**HUDSON RIVER PCBs REASSESSMENT RI/FS
RESPONSIVENESS SUMMARY FOR
VOLUME 2A: DATABASE REPORT
VOLUME 2B: PRELIMINARY MODEL CALIBRATION REPORT
VOLUME 2C: DATA EVALUATION AND INTERPRETATION REPORT**

DECEMBER 1998

**U.S. Environmental Protection Agency
Region II
and
U.S. Army Corps of Engineers
Kansas City District**

**TAMS Consultants, Inc.
Limno-Tech, Inc.
TetraTech, Inc.
Menzie-Cura & Associates, Inc.**

Figure A-1. Comparison of water column PCB concentrations calculated by the NEA capillary column method versus the USGS packed column method.

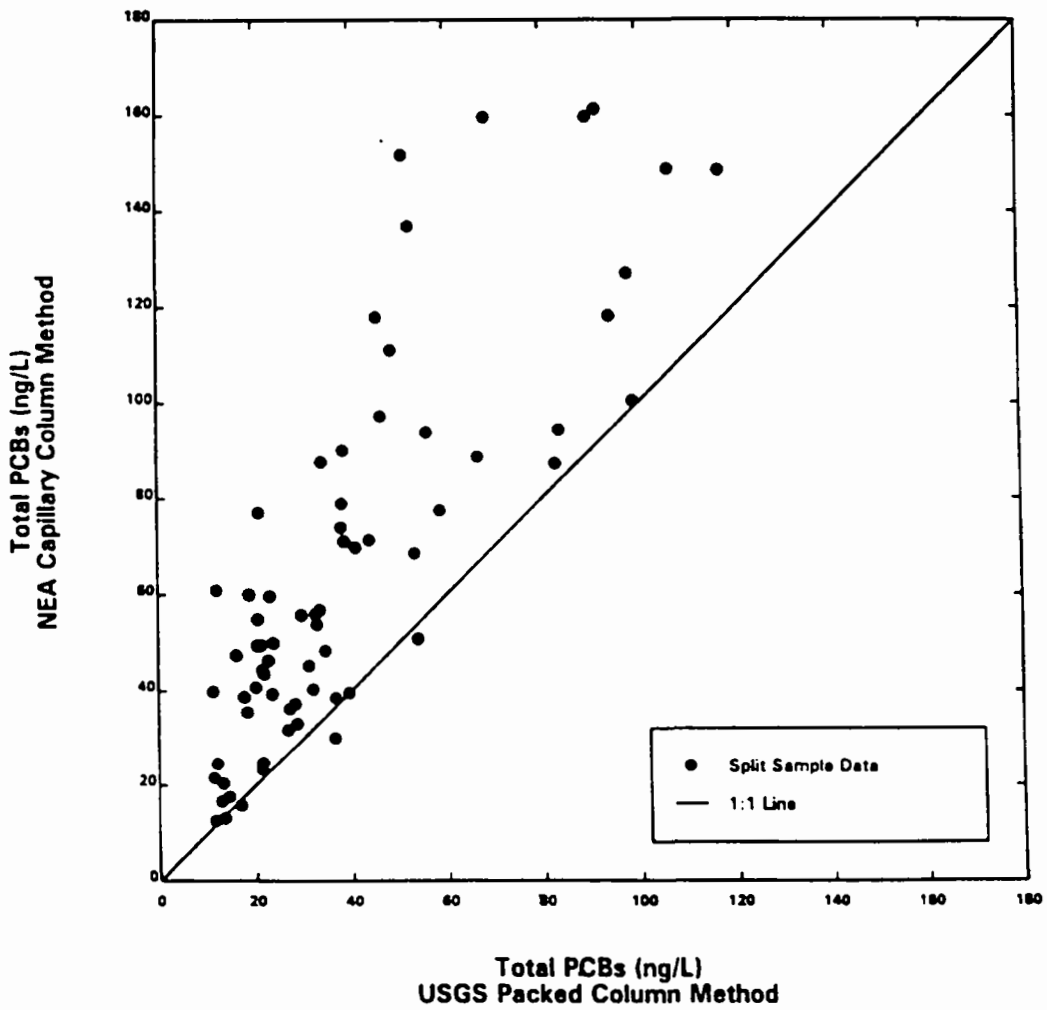
Based upon linear regression analysis of the difference between paired USGS and capillary column PCB data and the weight percent of homologues quantified by the capillary column method, the low bias in the USGS data (Figure A-1) appears to be strongly correlated with the concentration of mono-chlorinated biphenyls in the sample (Figure A-2). Addition of dichlorinated biphenyls to the regression strengthens the correlation suggesting that a portion of the bias may also be attributable to an underquantification of the dichlorinated biphenyls (Figure A-3). Therefore, it appears that the bias associated with the USGS data is directly related to the concentration of mono-, and to a lesser extent, the dichlorinated biphenyls. Since there is no direct measure of the mono-chlorinated biphenyls in the historical USGS data, a straight linear regression between capillary column and USGS total PCB concentrations was performed to assess the analytical bias in the USGS data. This regression was performed for each sampling station due to differences observed in mono- and dichlorinated PCB concentrations at the different stations in subsequent congener PCB monitoring programs.

Figure A-4. Comparison of total water column PCB concentrations calculated by the NEA capillary column method versus the USGS packed column method at Fort Edward, Schuylerville and Stillwater.

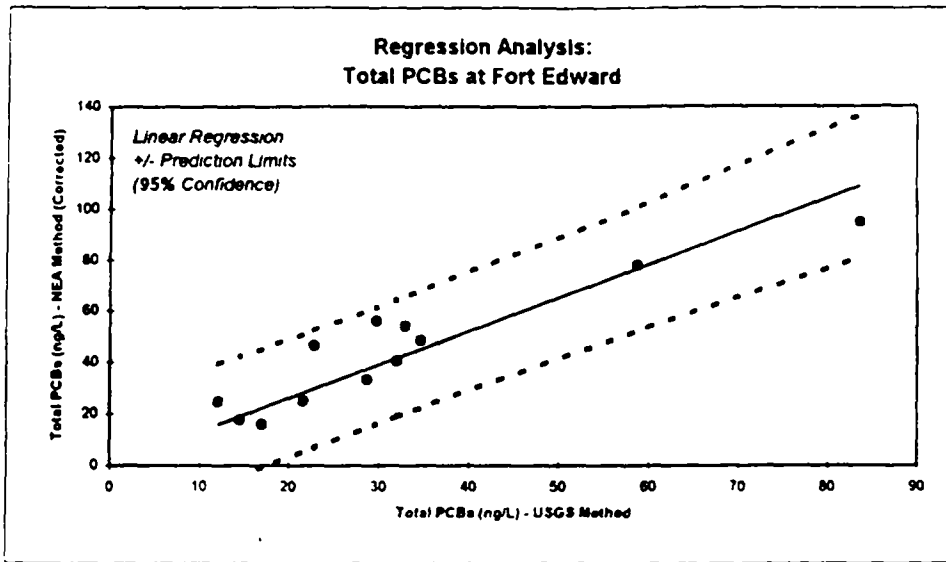
The results of the regression analyses for the different stations appear in Figure A-4. At the Fort Edward station, where water column samples contain only a small amount of mono- and dichlorinated biphenyls, the low bias in the USGS methodology is estimated at 29 percent (bias determined by the slope of the relationship). Similarly, PCB measurements by USGS methodologies underestimate Schuylerville PCB concentrations by an estimated 40 percent. Stillwater and

Figure A-5. Comparison of GE and EPA analyses of 1993 water column DB-1 capillary column peak 5 components (BZ#4 plus BZ#10) collected at Fort Edward and the Thompson Island Dam.

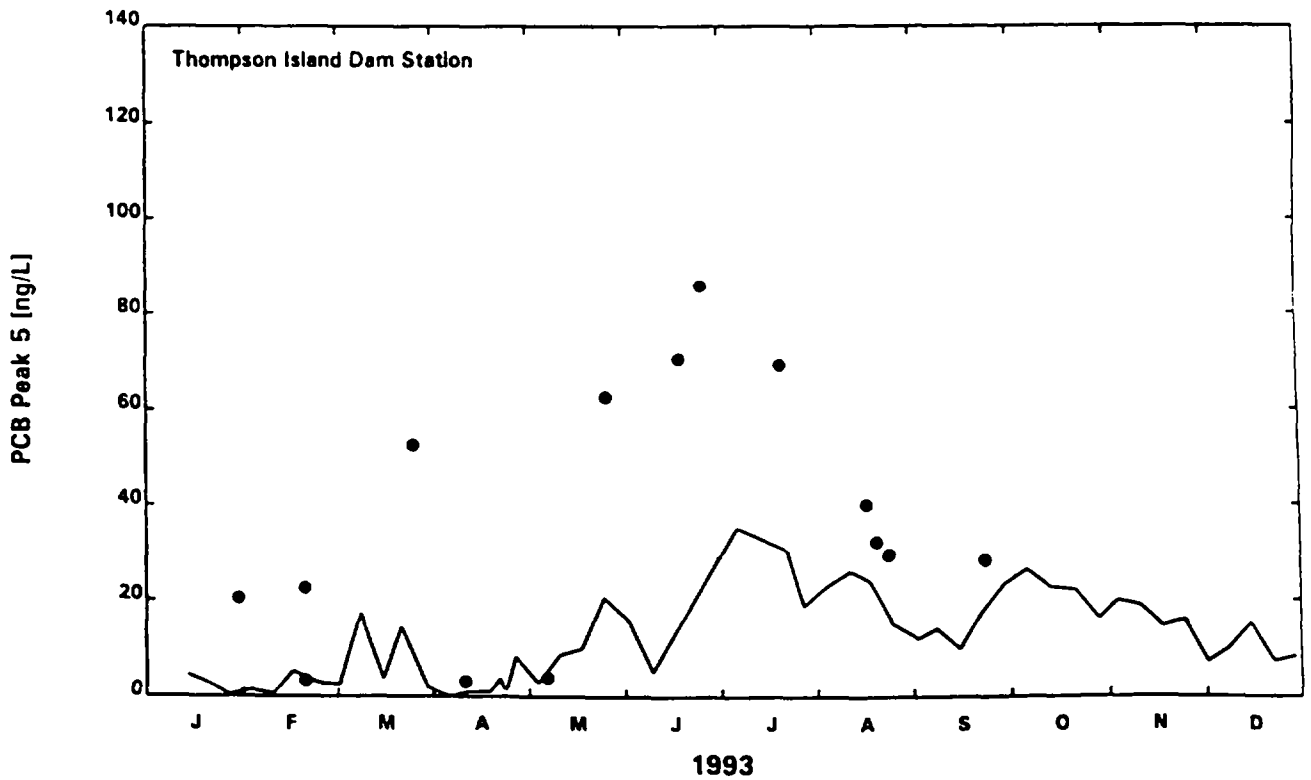
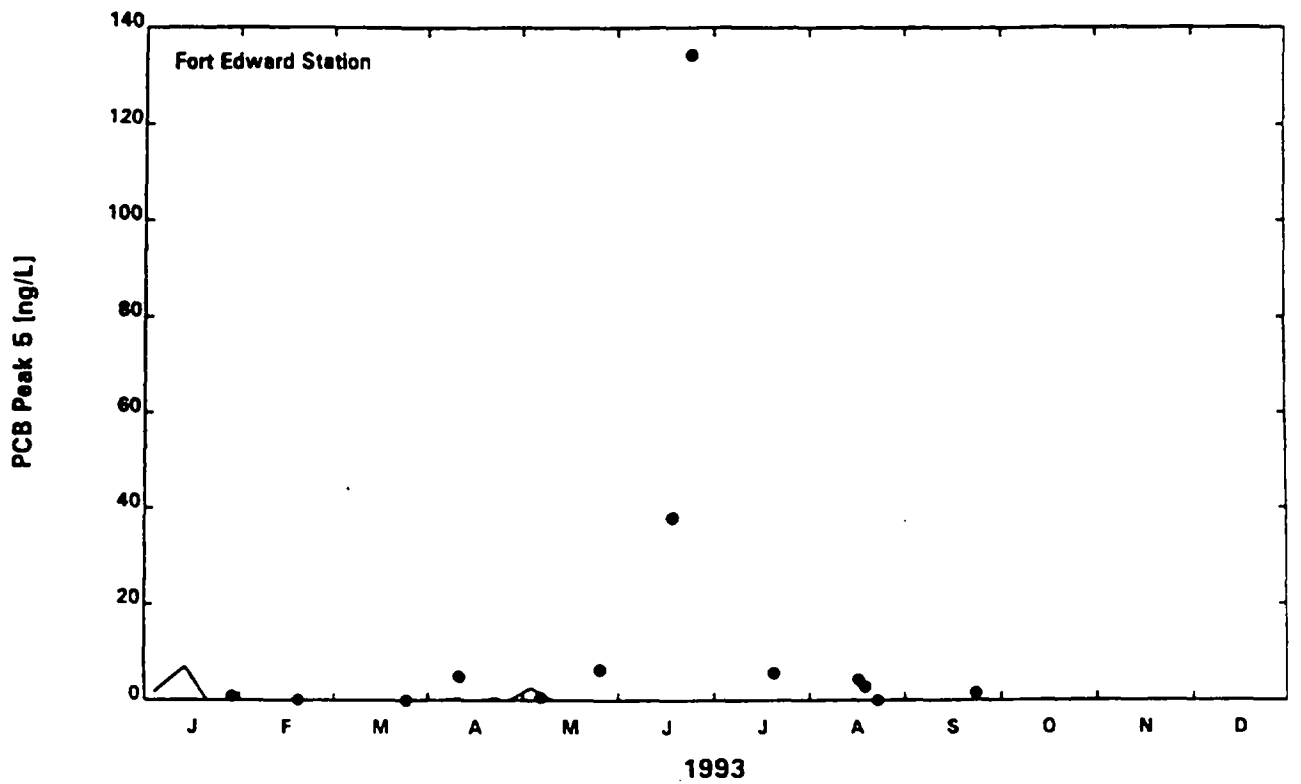
Biases in individual congeners may significantly affect data analyses used in developing an understanding of PCB fate and transport mechanisms in the Thompson Island Pool (TIP). For the case of PK5, the low bias of the GE data (Figure A-5) causes the TIP loading to be underestimated.

Figure B-1 Map of Hudson Falls plant site indicating locations of DNAPL and groundwater recovery locations which are color coded for composition.

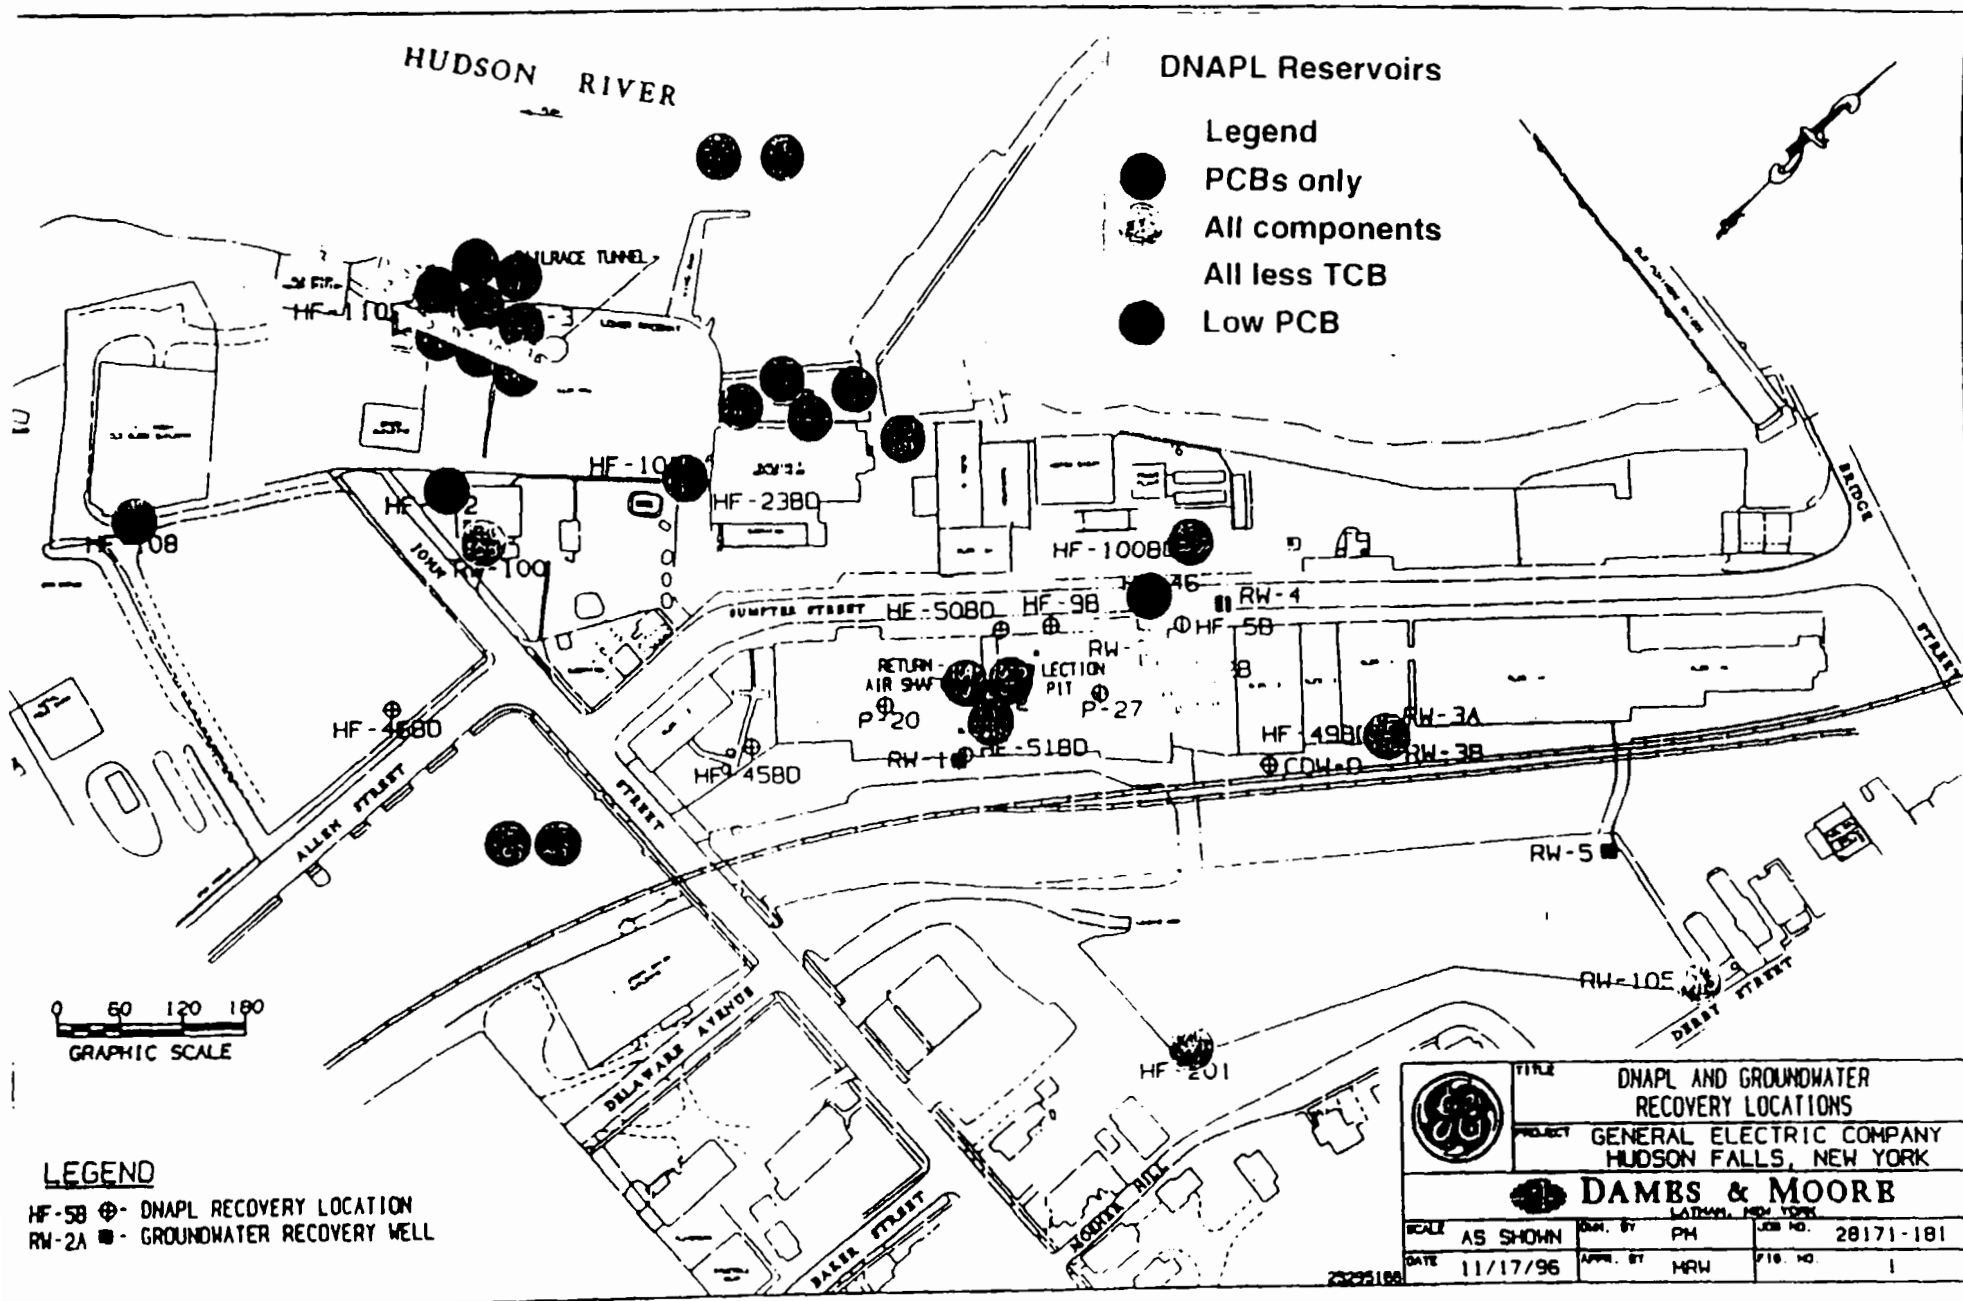
The four categories of DNAPL recovered from 38 different locations, including wells and in-river seeps, can be defined as 1) PCBs only (primarily PCBs), 2) all components (PCBs, PXE, BEHP and TCB), 3) all components less TCB (PCBs, PXE and BEHP), and 4) low PCBs (containing less than 50% PCBs, and variable quantities of PXE, BEHP and TCB). The presence of these four categories of DNAPL suggest that there are at least four unique DNAPL reservoirs present in the vicinity of the plant site. These DNAPL reservoirs are located as follows and are shown in Figure B-1:

Figure E-1. Partition coefficients as a function of river mile calculated from EPA Phase 2 water column monitoring transect studies 2-6.

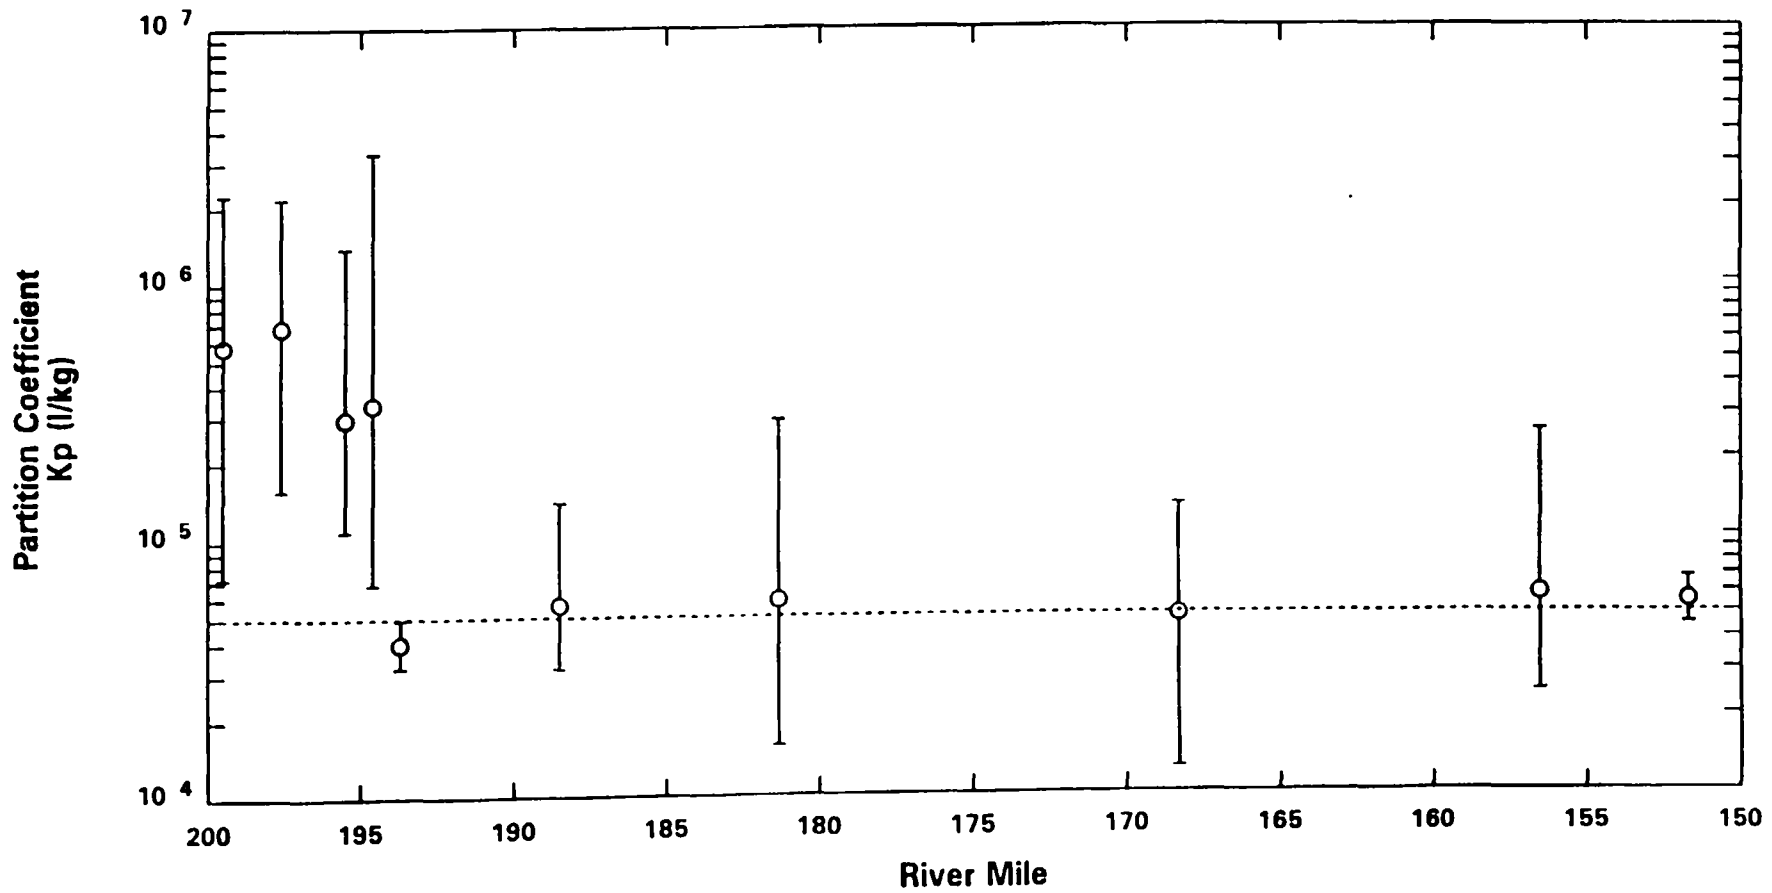
different behavior from those below the dam. Figure E-1 shows the average and range of total PCB partition coefficients for Transects 002-006 vs. river mile. Note the relatively constant values for K_p beginning at the TI Dam of about 50000 l/kg and the distinctly higher values upriver. This difference cannot be attributed to a change in organic content of the solids. Figure E-2 shows estimated log K_{OC} values plotted against log K_{OW} (as reported by Hawker and Connell). For the Thompson Island Dam, Schuylerville, and Waterford stations, the K_{OC} pattern is relatively uniform throughout all transects, and is reasonably well represented by K_{OW} . The Fort Edward station estimates show a much different pattern, being generally higher than the other stations and exhibiting a higher degree of variability.

Figure E-3. Log K_{oc} of BZ#10 as a function of inverse temperature. Only Transect studies 1-6 from the Thompson Island Dam to Waterford: Left, with temperature correction; Right, without temperature correction.

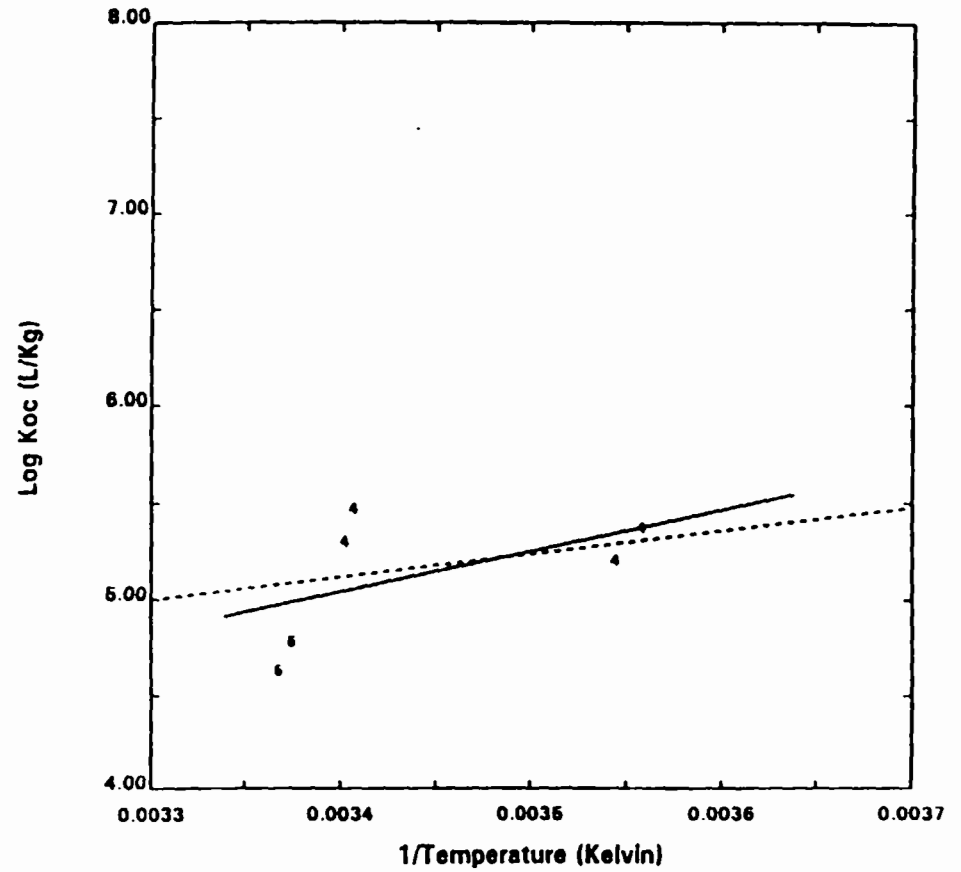
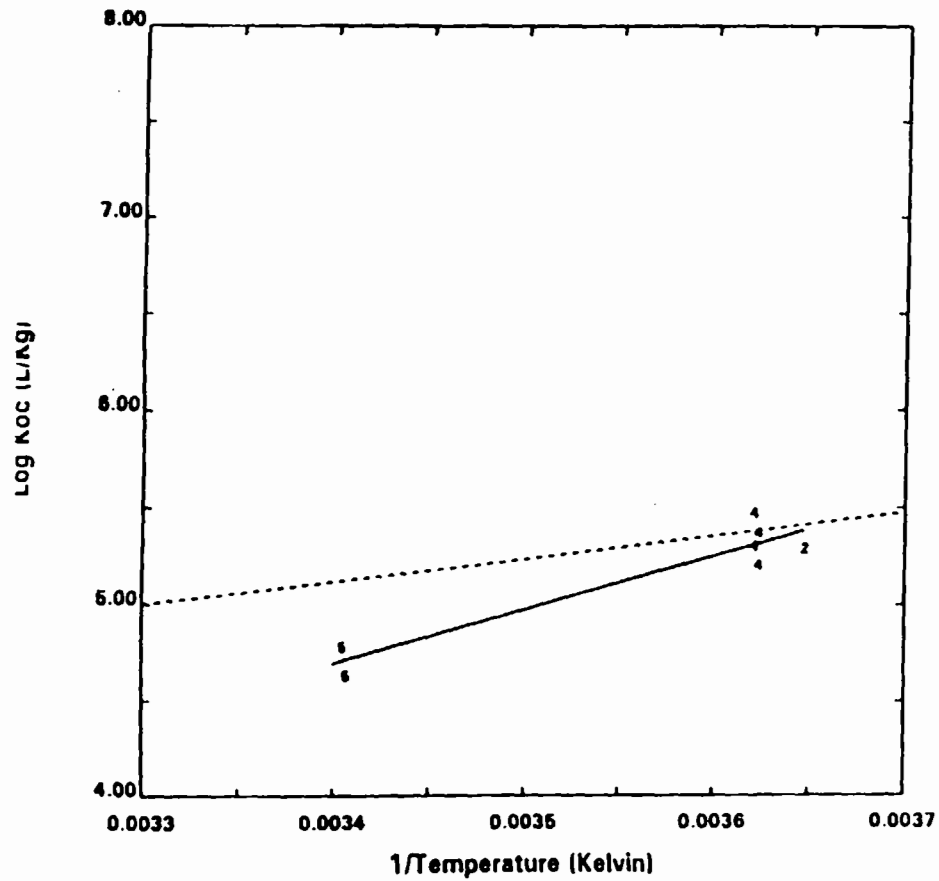
The analysis of the temperature dependence of partition coefficients (p 3-16) is based upon historical data reported in Warren, et al (1987). It is not clear why this data was used to determine the temperature dependence of partition coefficients when the Phase 2 data collected covers a sufficient range in temperature to determine temperature dependence directly. Figures E-3 and E-4 show $\log K_{oc}$ vs $1/T$ for congeners 10 and 27.

It should be noted that these values of temperature have been corrected to ambient river temperature. Figures E-3b and E-4b show $\log K_{oc}$ vs $1/T$ for congeners 10 and 27 based on the temperature reported in the Phase 2 data. That this temperature is not ambient is evident by the large temperature differences within transects as well as the reporting of high (~20 degC) temperatures in the early Spring surveys. Figure E-5 shows a comparison of ambient TI Dam water temperature data collected by OBG as compared to those reported in the Phase 2 transect data. In all transects the reported Phase 2 temperature is higher than ambient. It is not clear when and where the Phase 2 temperatures were taken, especially in relation to the time of filtration of water samples. If the filtration was performed before samples reached equilibrium at the higher temperatures, values of $K_{oc}(20)$ will be biased high.
